VALUE ENGINEERING REPORT

CR 665 (Carbondale Road) / I-75 Interchange
Project No. IM-STP-75-3(208) Whitfield County
PI No.: 610890

October 23, 2007

MACTEC Engineering and Consulting, Inc.
3200 Town Point Drive NW, Suite 100
Kennesaw, GA 30144
(770.421.3346)

ITEM N^o: D-1
 CLIENT: GDOT
 Sheet 2 of 7

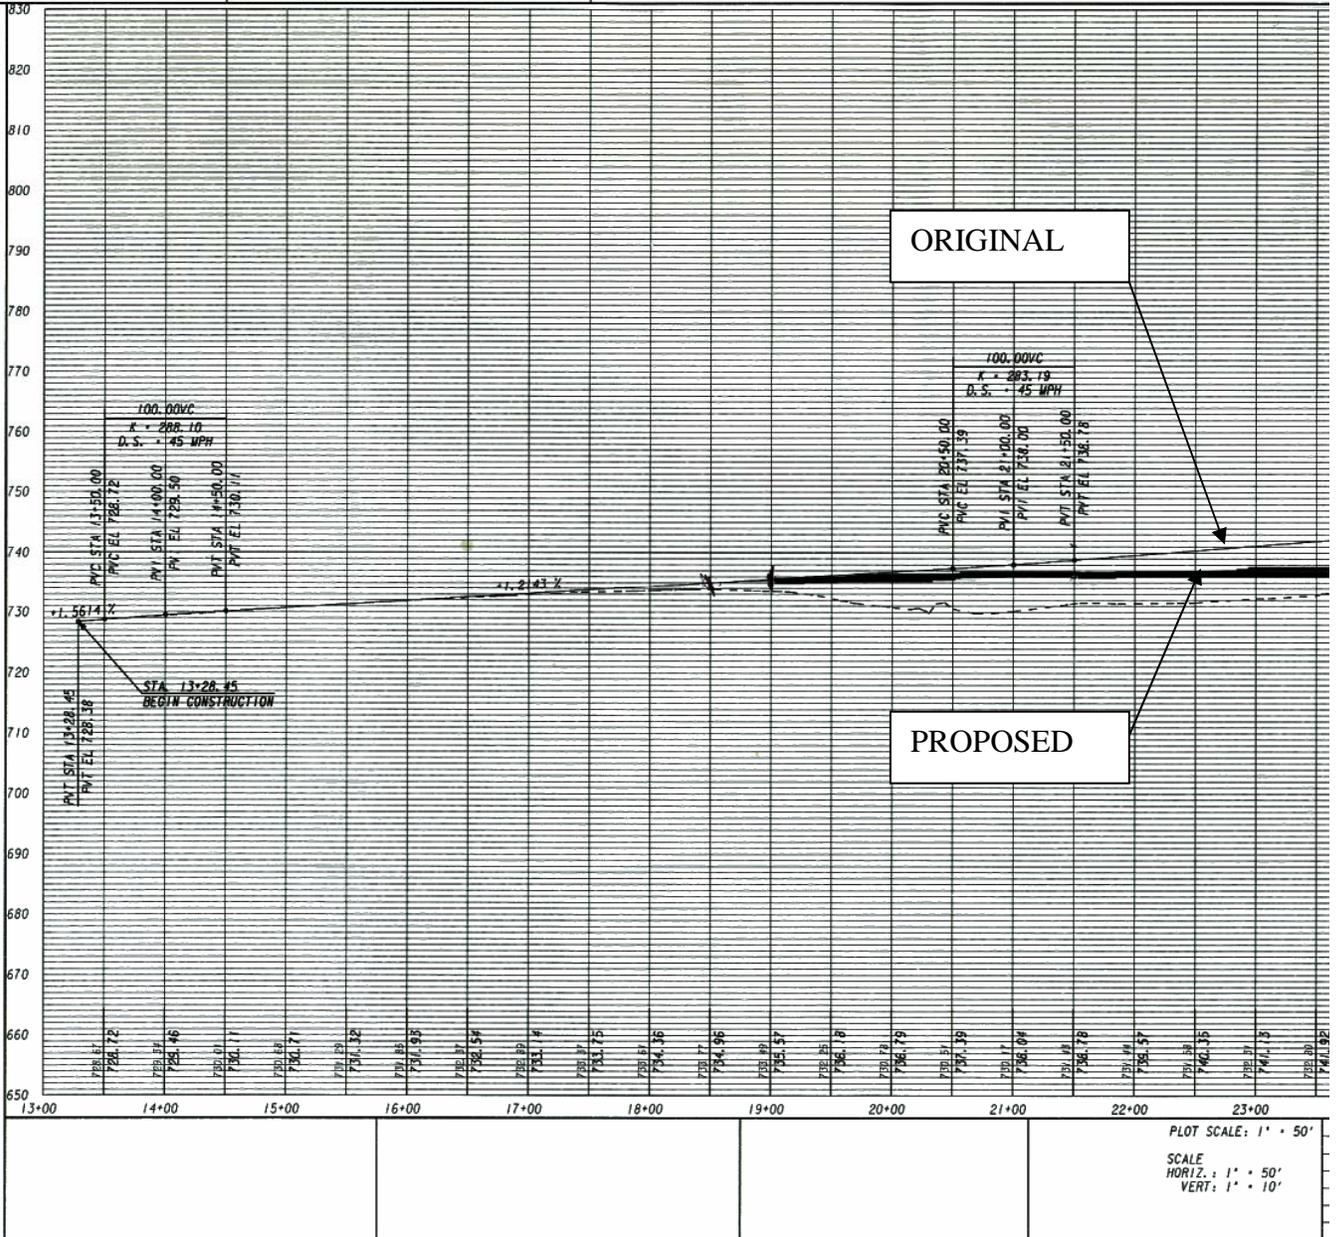
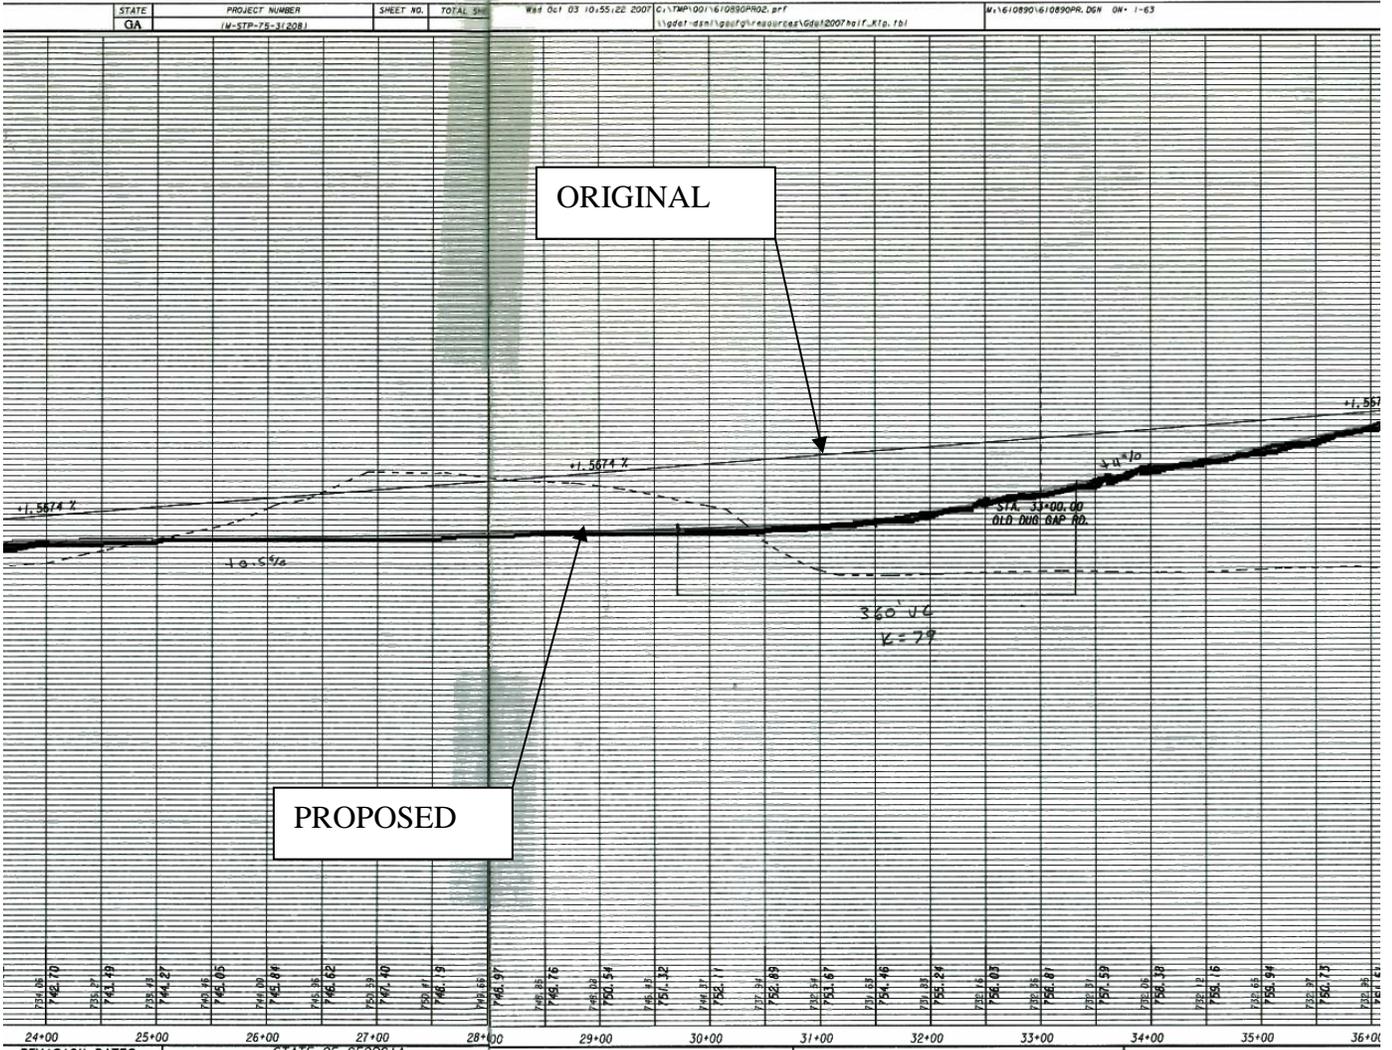
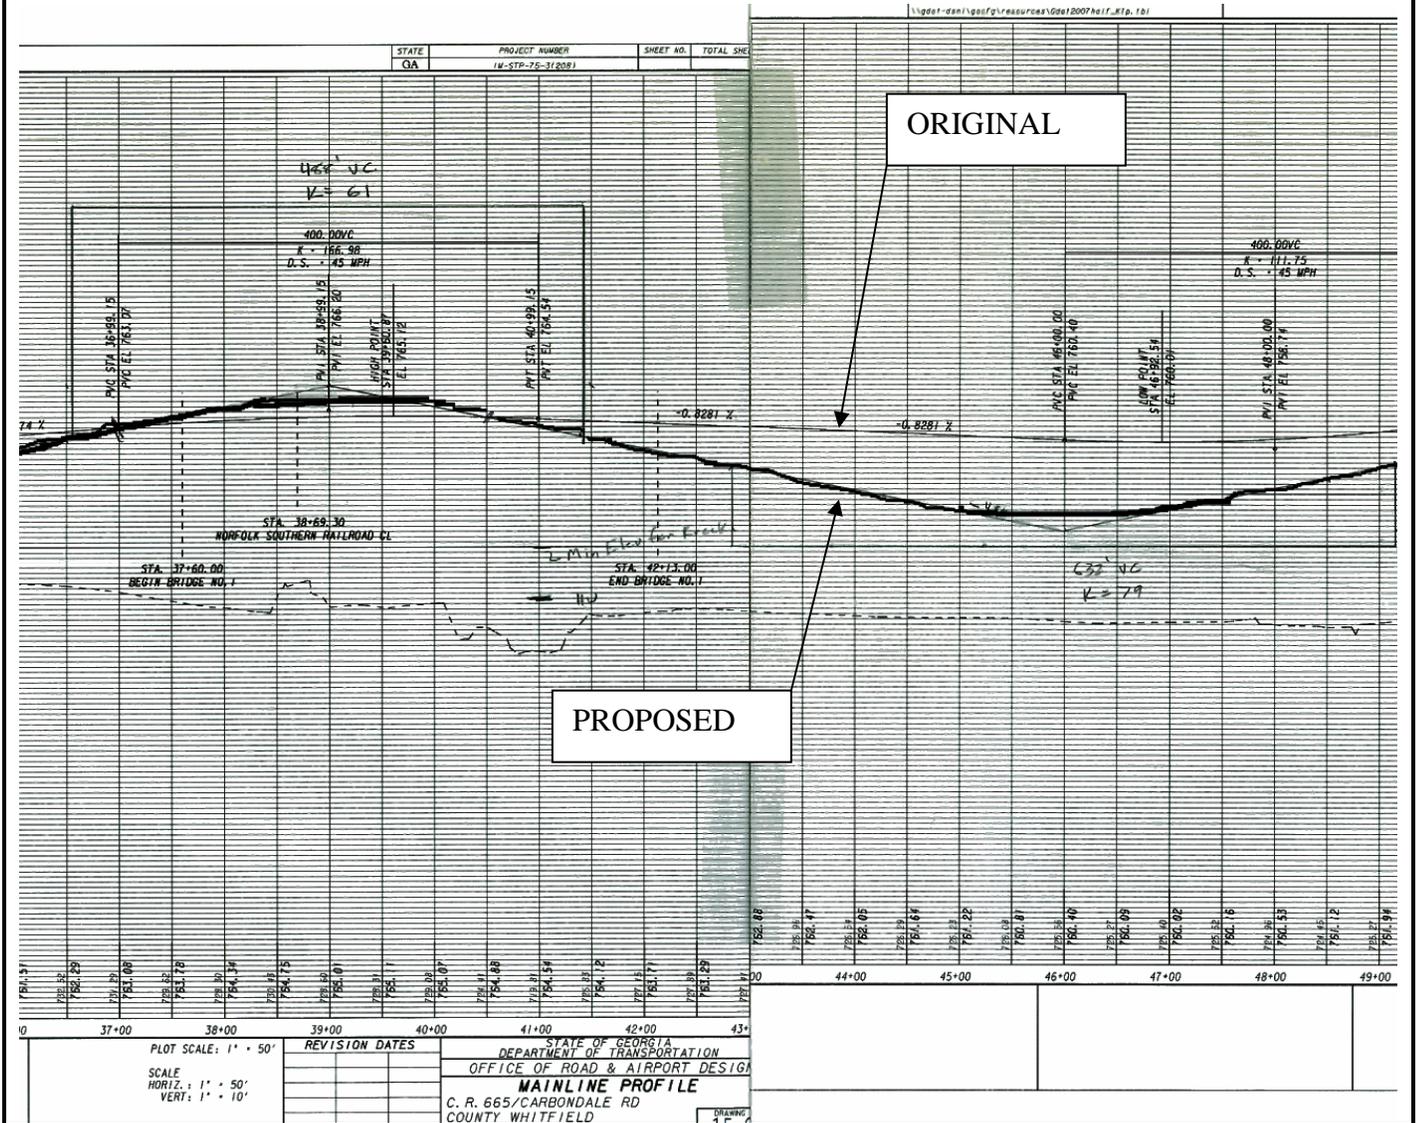
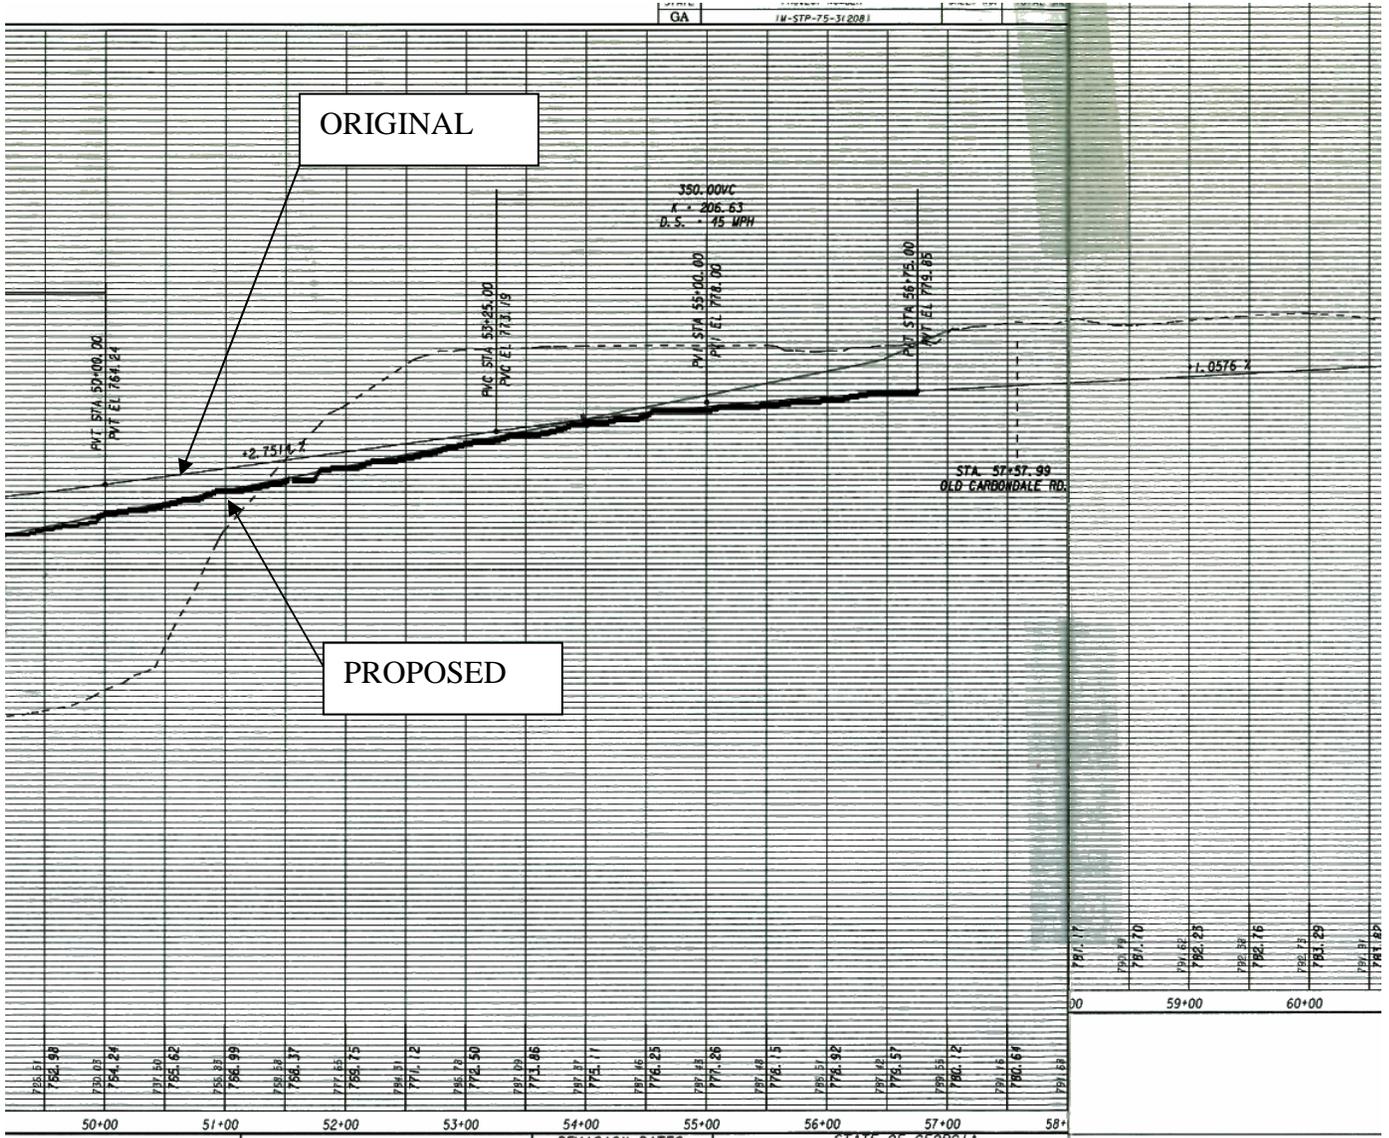
IDEA No.:	PAGE No.:	CREATIVE IDEA:
D-1	1 of 7	Revise Profile at stations 18+00 to 37+00 and stations 41+00 to 54+00 to reduce earthwork
Comp By: GG	Date: 10/3/07	Checked By: DCW Date: 10/4/07

The proposed change reduces the amount of borrow by lowering the profile to reduce the fill height and increases the amount of cut to bring the earthwork closer to balancing. However, the project is still a borrow project from an earthwork perspective. Additional lowering of the profile and increasing the amount of cut on the project near Station 54+00 will offer additional savings.
